## Improved Connector and Pigtail for GM Fuel Pump Modules Technical Service Bulletin

### The Problem:

**Modules with Improved Connector and Included Wiring Harness Have this Decal on the Package End-Flap.**

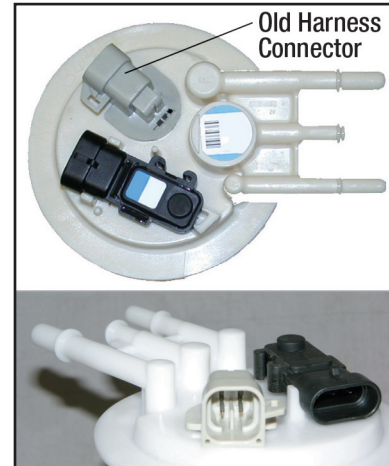
New wiring harness included.  
Refer to enclosed installation instructions.

### Old Design—Top & Side View

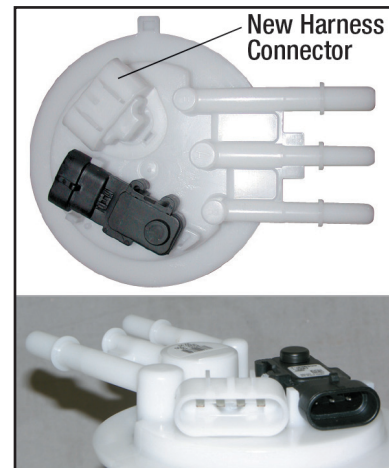
Many GM vehicles from 1988 to 2005 have electrical connectors on the fuel pump module that may become loose over time due to vibration, leading to faulty, high-resistance connections. The symptoms – burned or melted connectors and pins – lead to a voltage drop situation where low or no voltage can cause the module to stop pumping.

**GM Fuel Pump Module with Old Harness Connector**

Airtex's latest fuel system solution provides a quick and reliable fix for burned or melted wiring harness connections on certain GM in-tank fuel pump applications. The faulty OEM design connector has been replaced with a new OEM design that eliminates the burned or melted connectors and pins problem.

**GM Fuel Pump Module with New Harness Connector**
